35/13-06V 37 Oxford Street Chevy Chase Village Historic District, 35/13

#### **MEMORANDUM**

Historic Area Work Permit # 385729 RETROACTIVE REVISIONS to the approved Landscape Plan

#### HISTORIC PRESERVATION COMMISSION STAFF REPORT

CCLC HYMORIC RENDERING

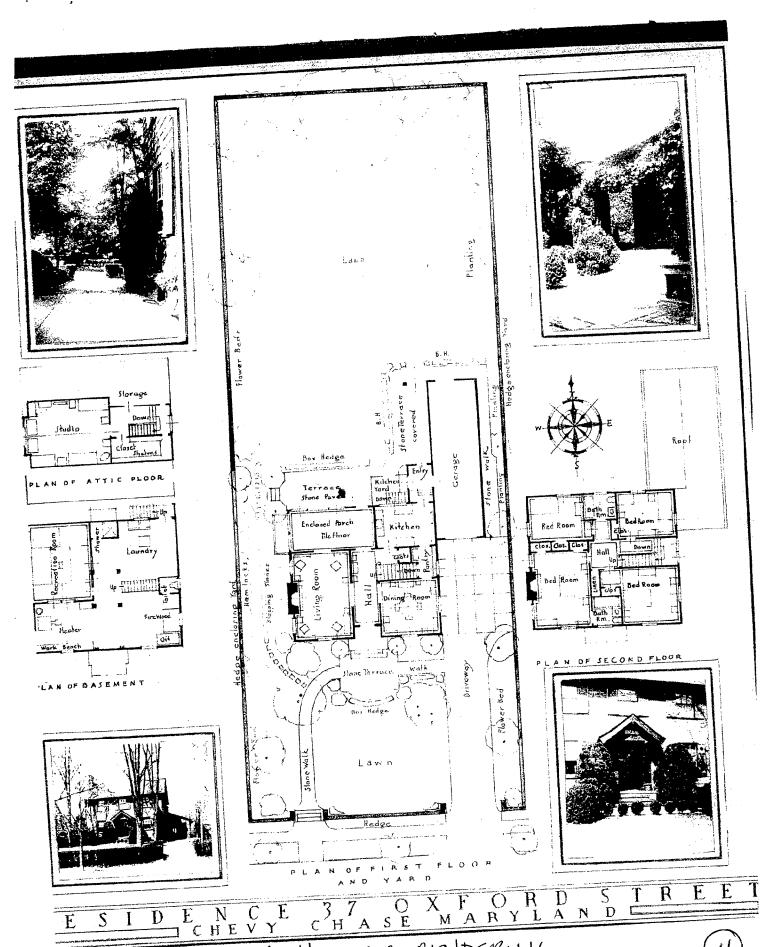
Staff feels that the proposed design meets the criteria outlined in the Chevy Chase Village Guidelines. However, we would encourage the applicant to plant a hedgerow in front of the new retaining wall. This would provide a green buffer, which historically existed on this property, which can be seen in the attached historic photos and rendering on circle 4.

- 2. The applicant will consider the replanting of a hedgerow along the new, retaining wall to buffer some of the stone material, which has been introduced to the site, and to recreate a historic feature on the property.
- 3. The front walkway reconfiguration, which was to be perpendicular to the public sidewalk, approved by the 6/22/05 HAWP application, is not to be constructed.

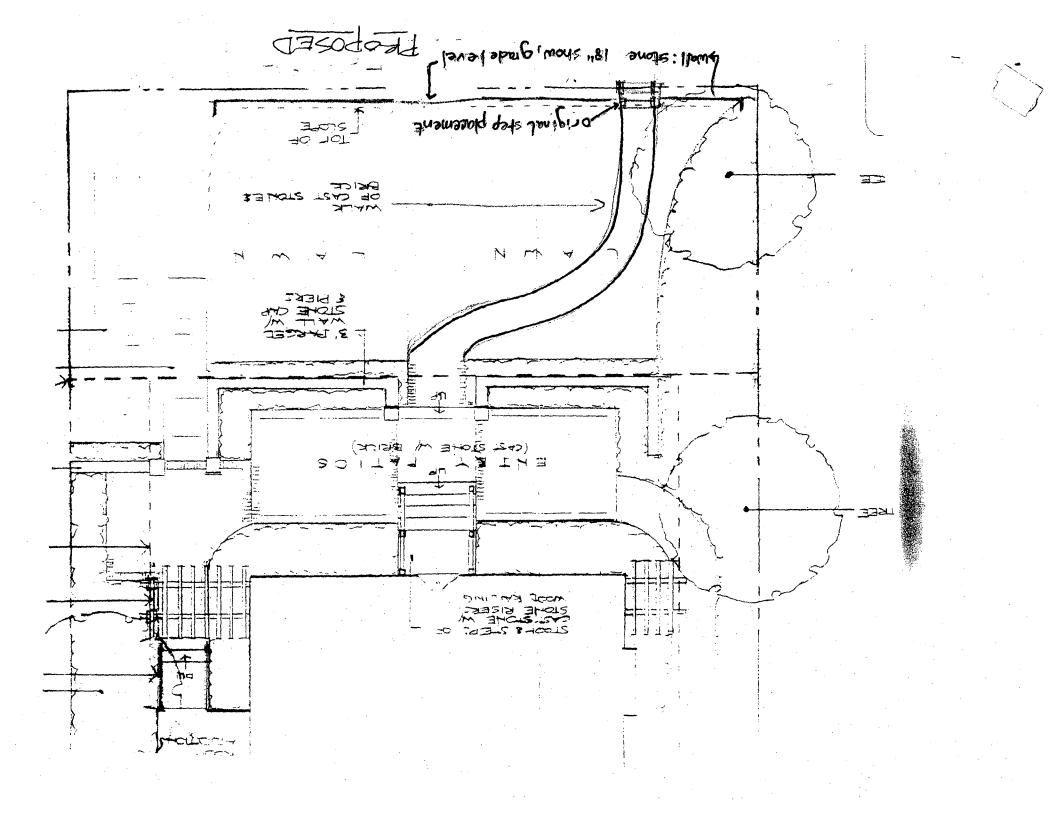
- 1. New stone is put on top of original brick steps.
- 2. New stone has replaced original stone.
- 3. Cheek wall are on top of original brick walls.
- 4. Cheek wall will be 24" high 24" deep 16" high and 24" deep. Will step up with grade.
- 5. Cheek walls will not have an overlapping cap.

- 1. 42'4" from house/40" from sidewalk
- 2. 18" of stone will show
- 3. Wall will link to cheek wall on steeps
- 4. Wall will rap on property edges
- 5. Wall will be 1-2" below upper lawn

toll removed and set back 42' 4" off the house

current steps

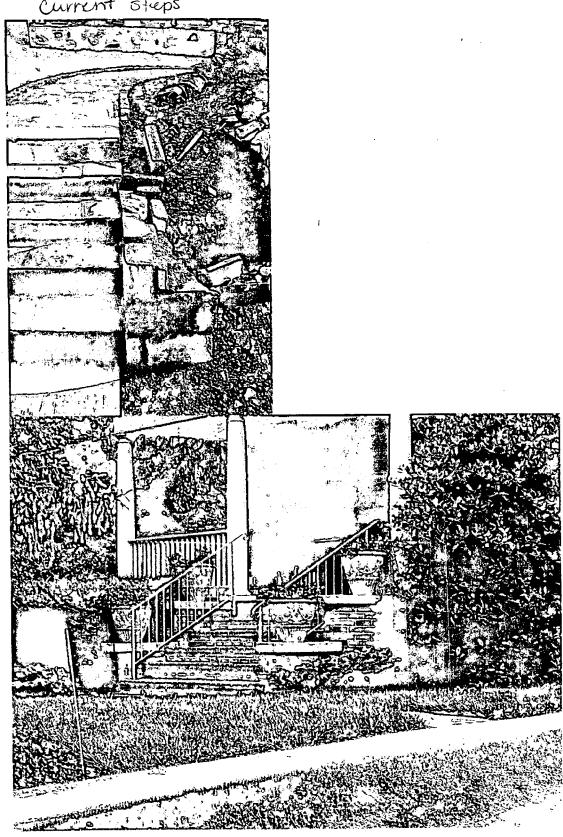
checkwall and steps on top of all steps

JUNE 2005 APPROVED PLAN

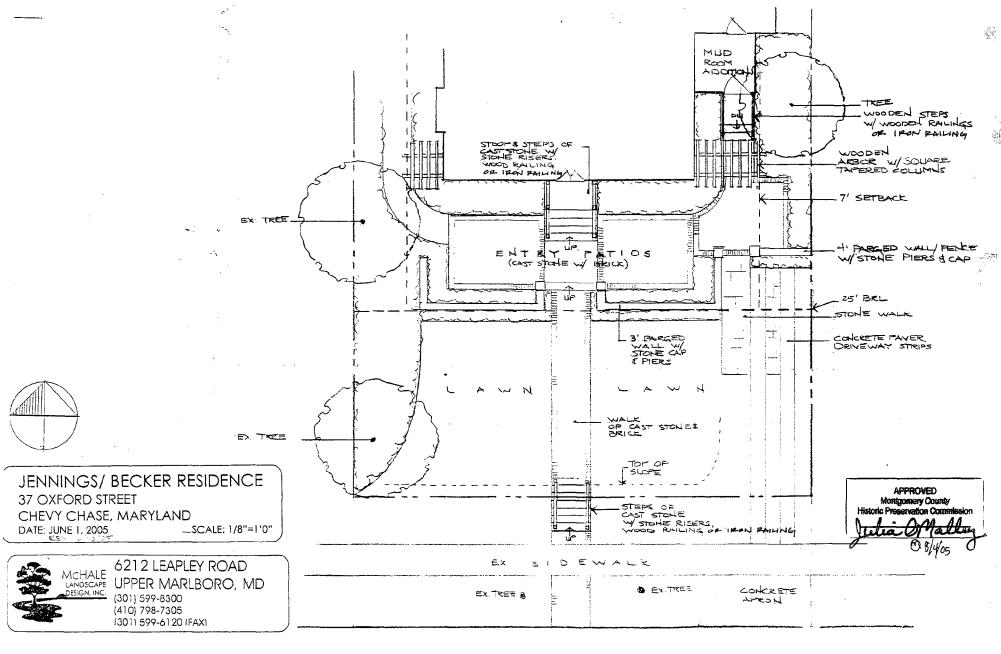
Since the proposed revisions to the landscape plan amend the location of the front walk, staff recommends a condition stating specifically that the previous front walk location, which was perpendicular to the public sidewalk, be voided from the application.
